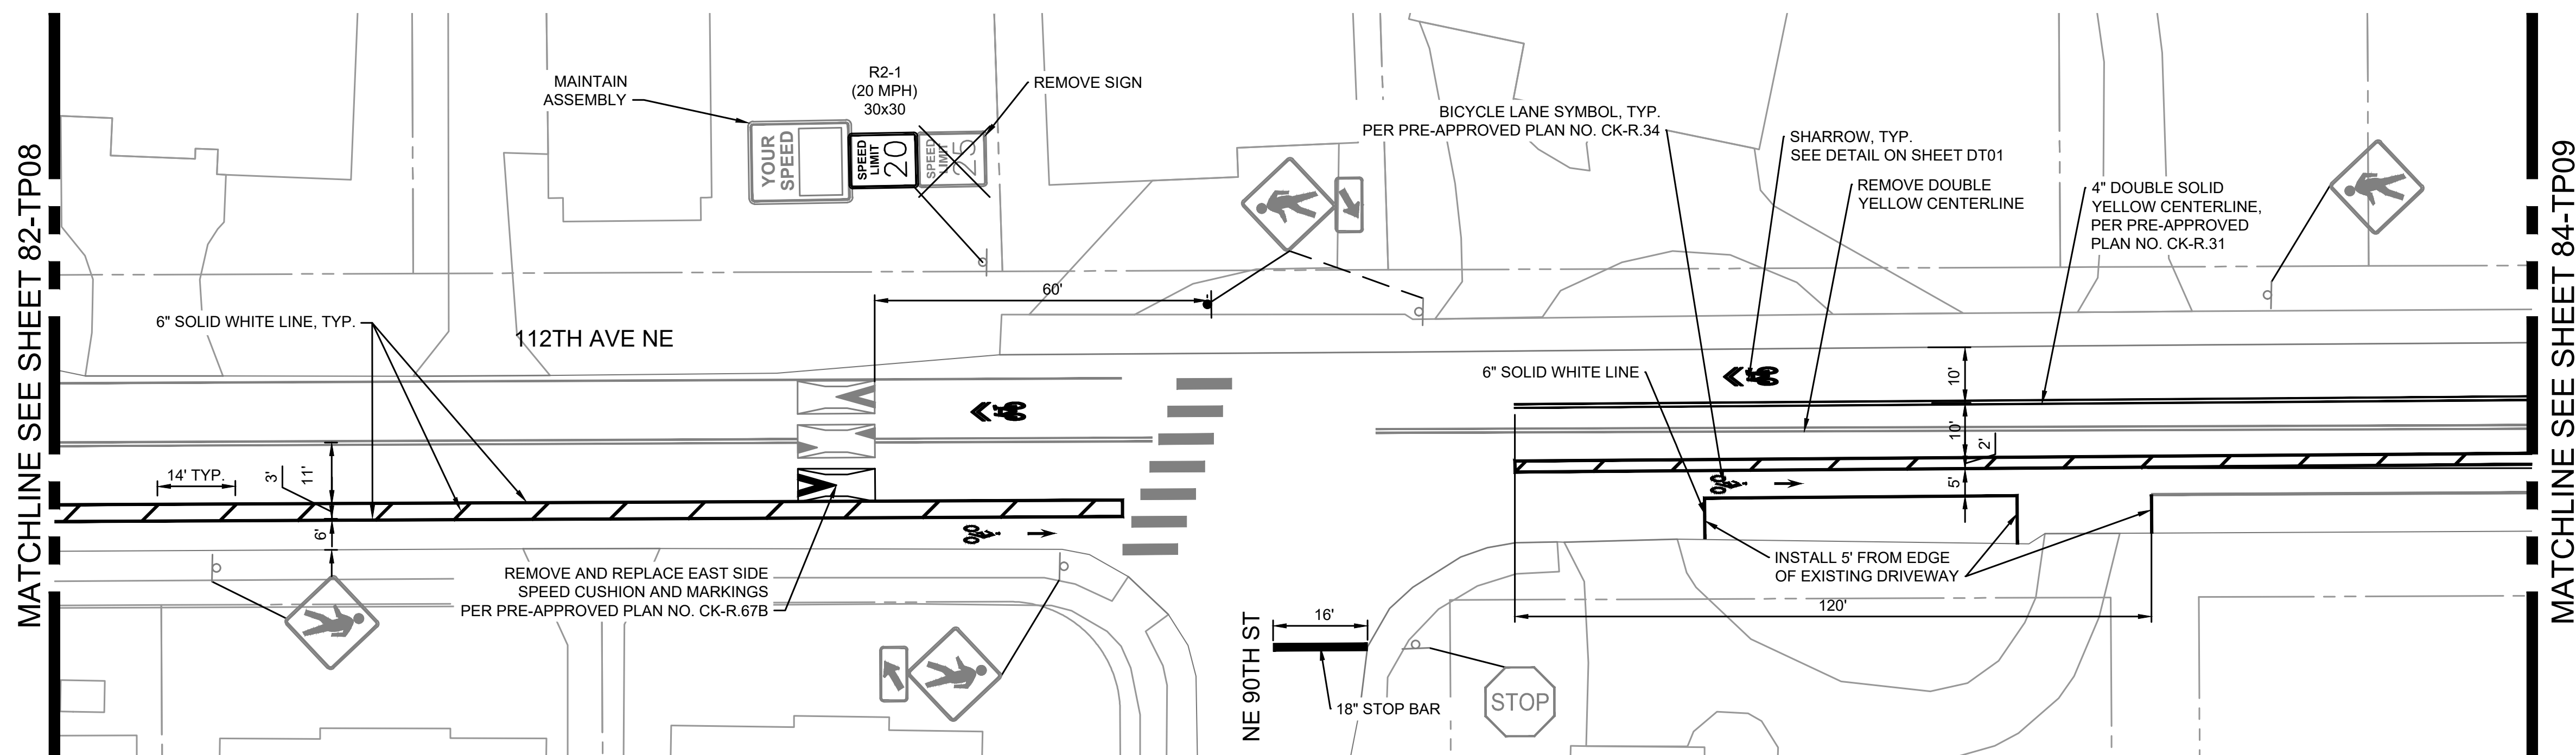
**Q: Why does the center-lane shift at Northeast 90th Street?**

A: To minimize the bicycle lane's conflict with a catch-basin and bus stop.

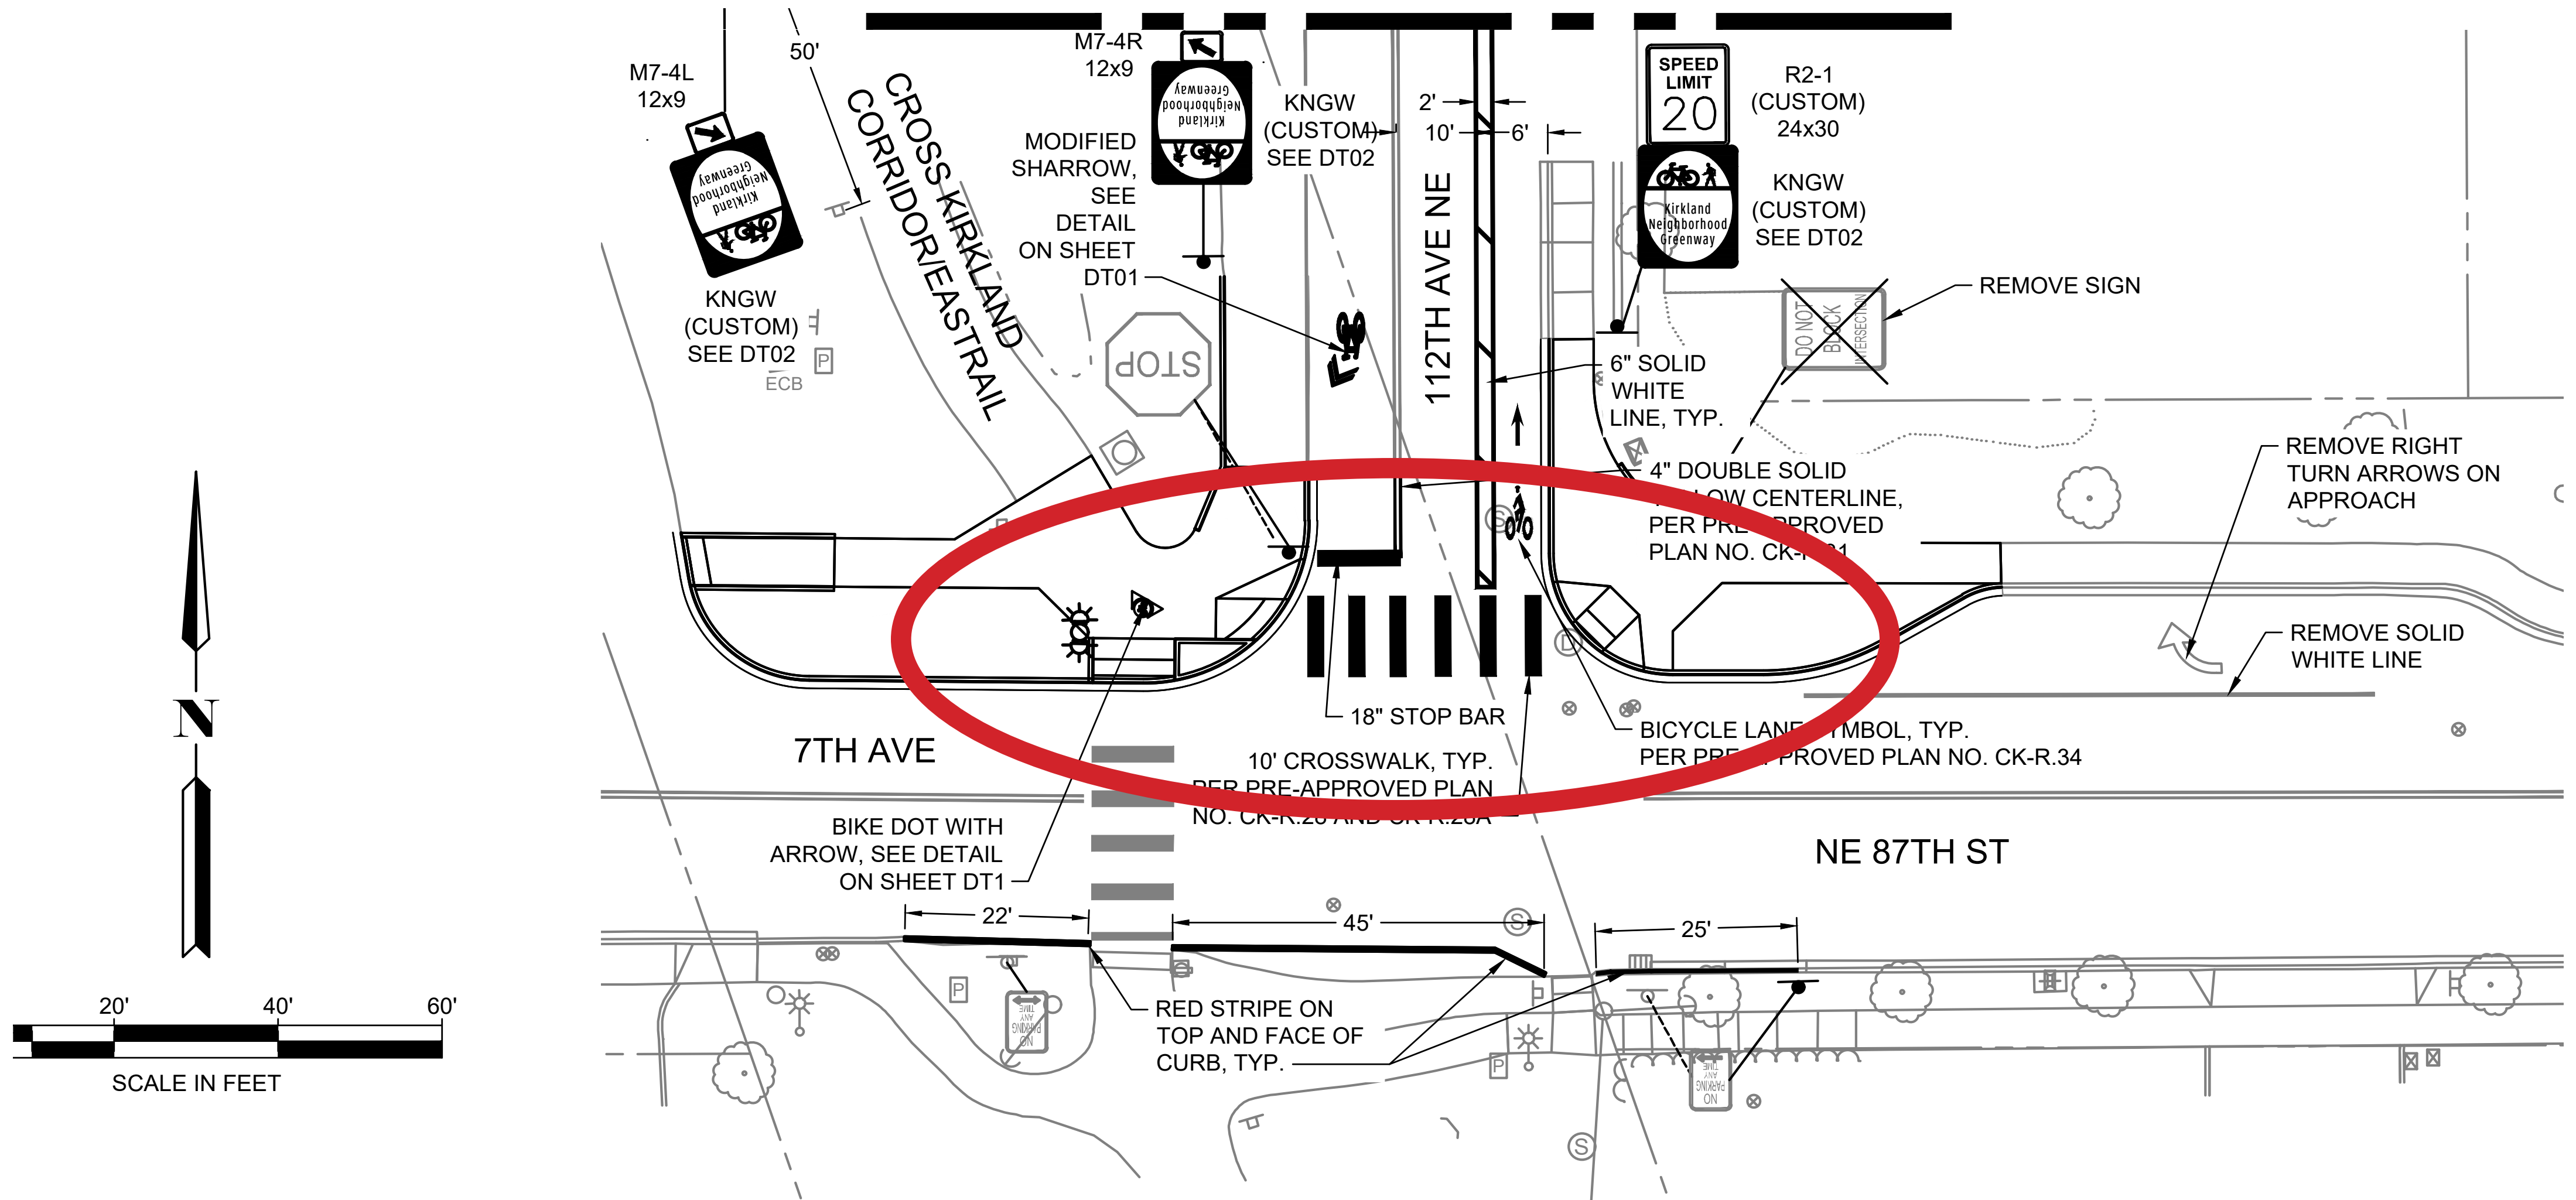
**Q1: Can bike lanes be better?** *(provide physical barrier & prevent swerving)*

A: Yes! Delineators or extruded curb could provide a physical buffer and prevent cars from swerving around speed cushions.

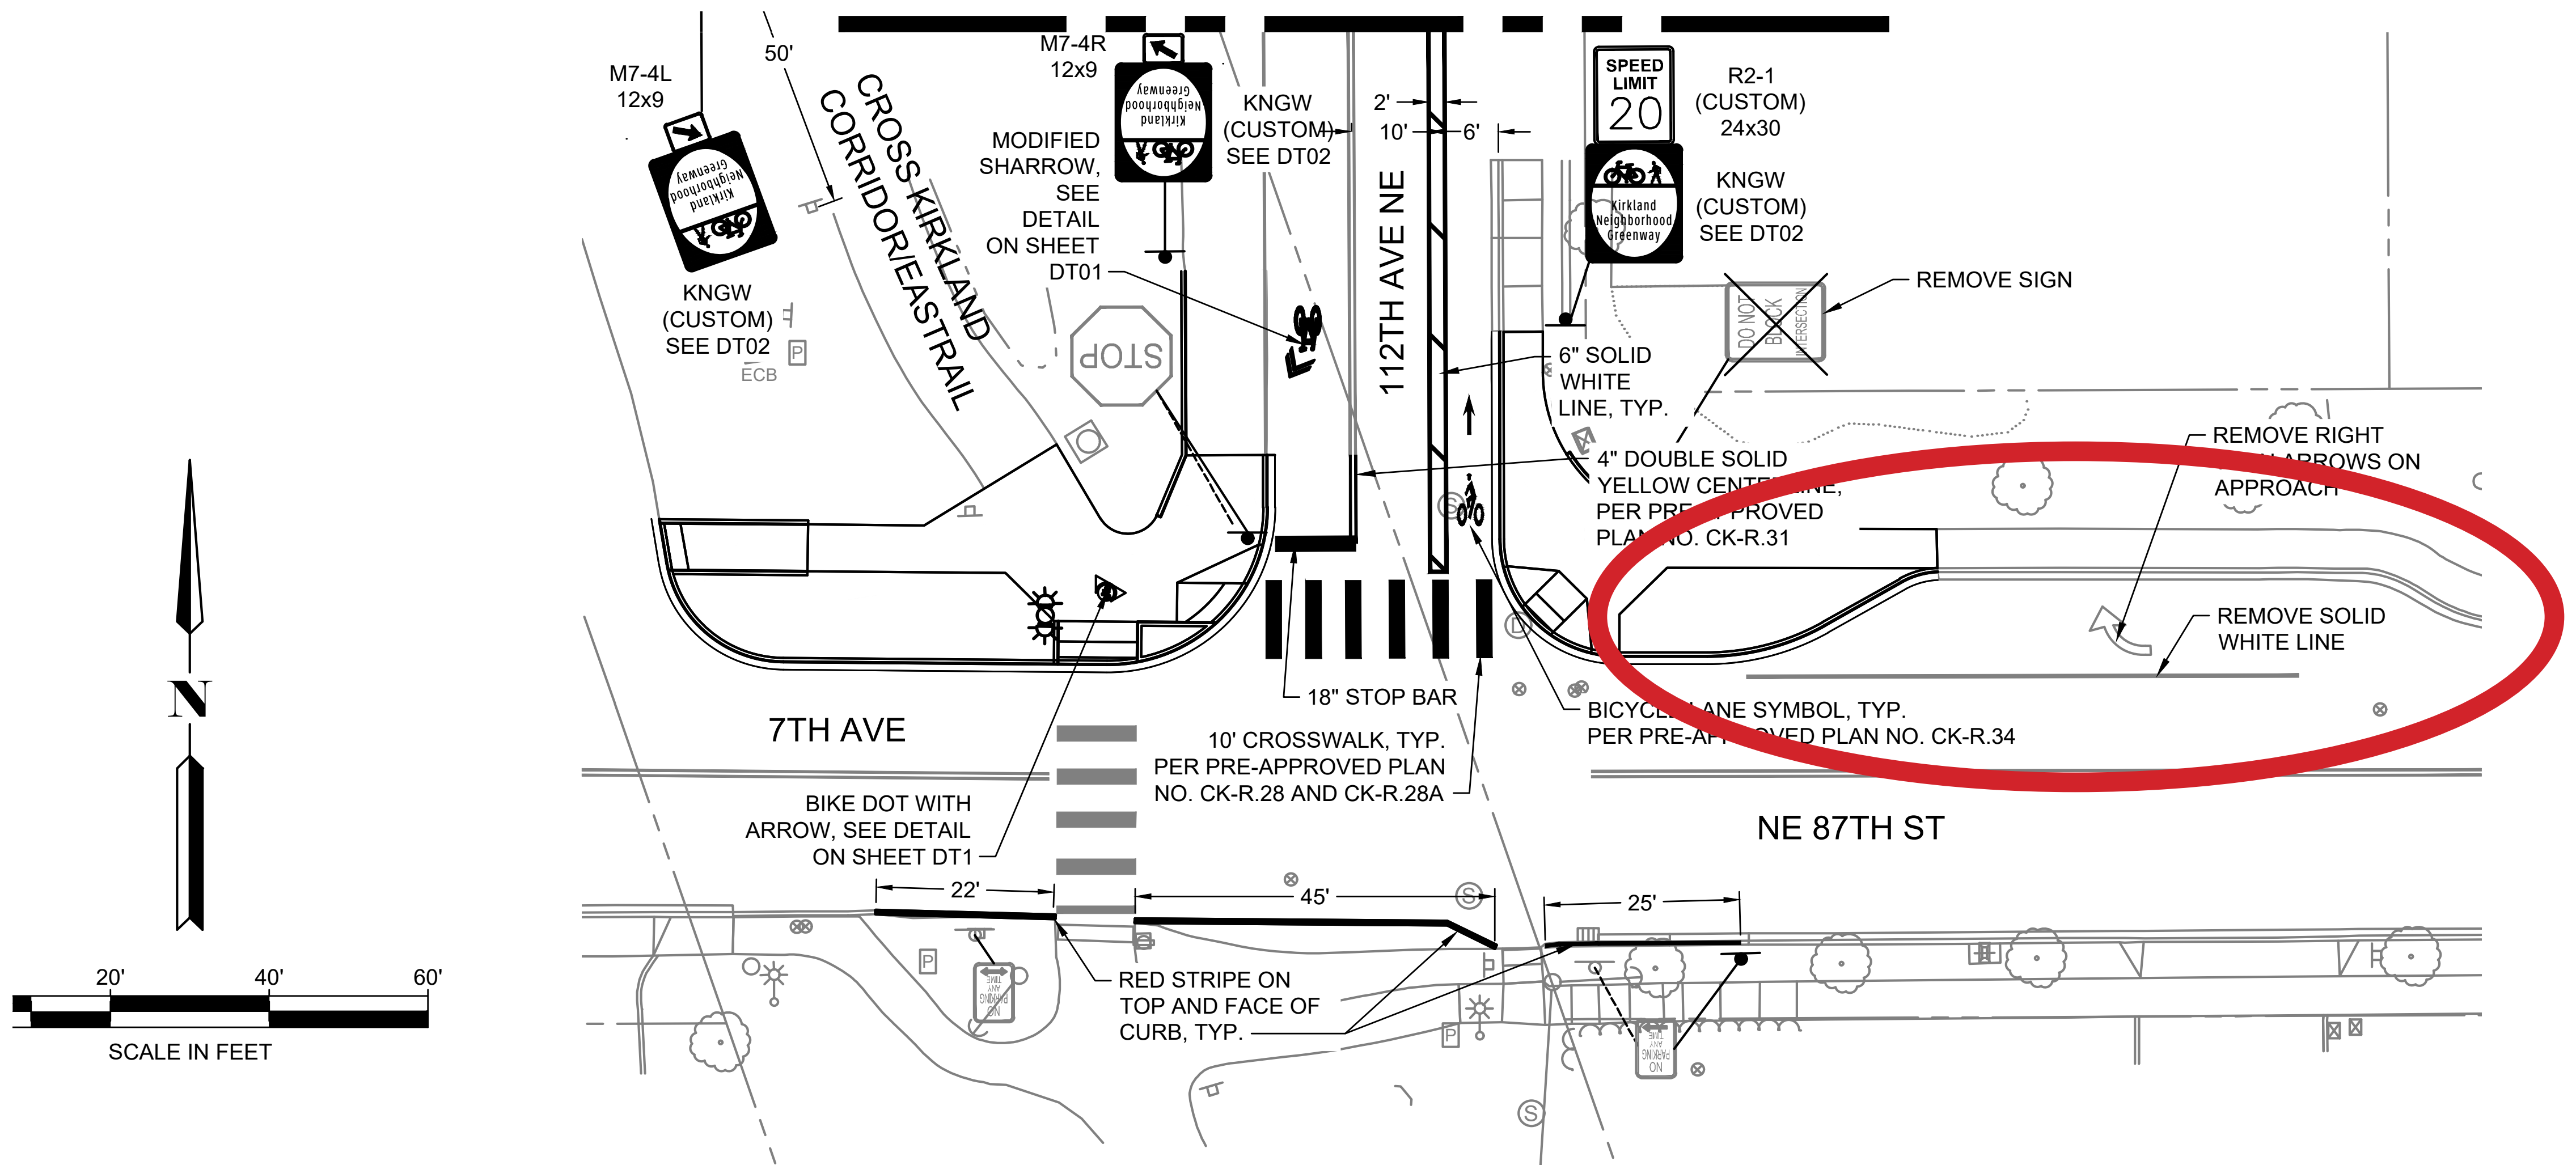
**Q: Do we get a crosswalk?**

**A: Yes!**

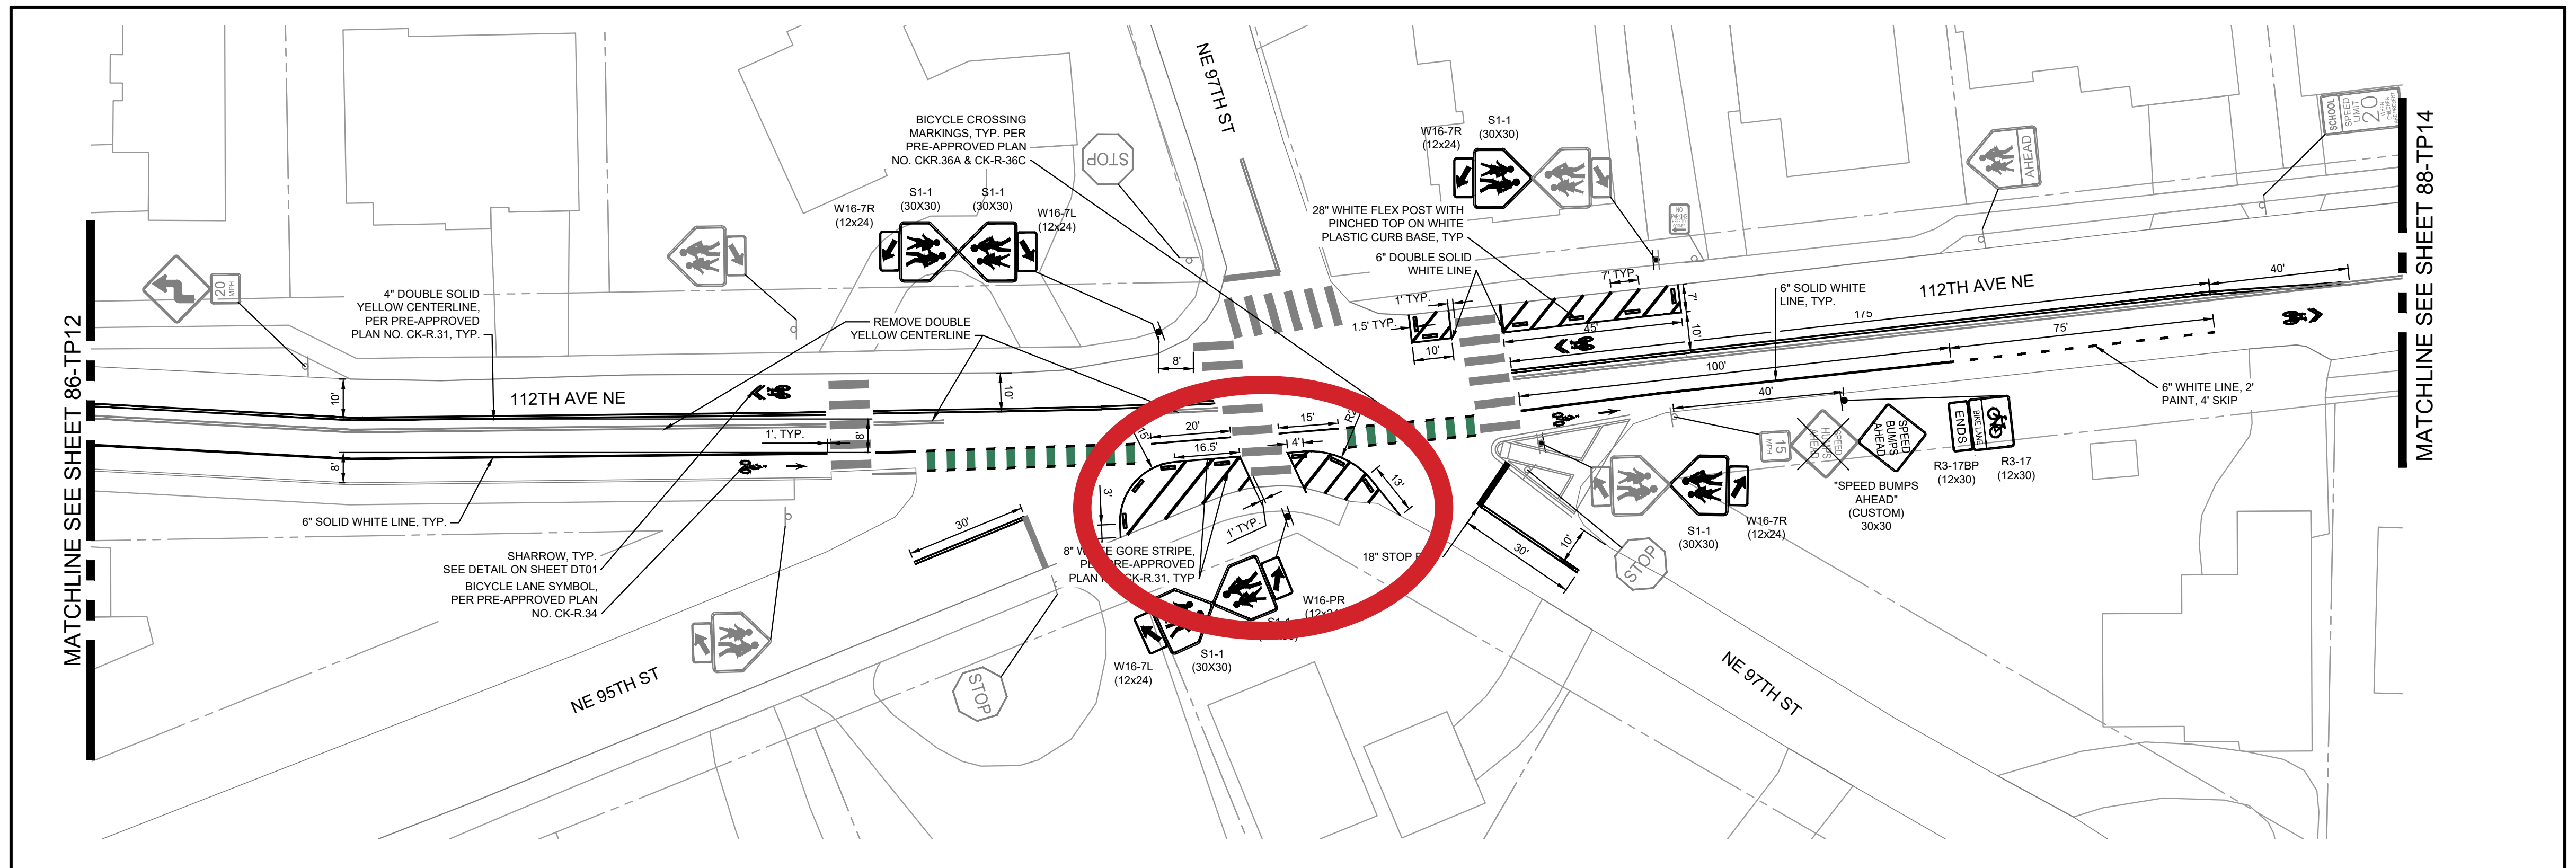
**Q: What's the purpose of bump-out at Northeast 95th Street?**

A: Five-way intersection, slows people down, shortens crossing.
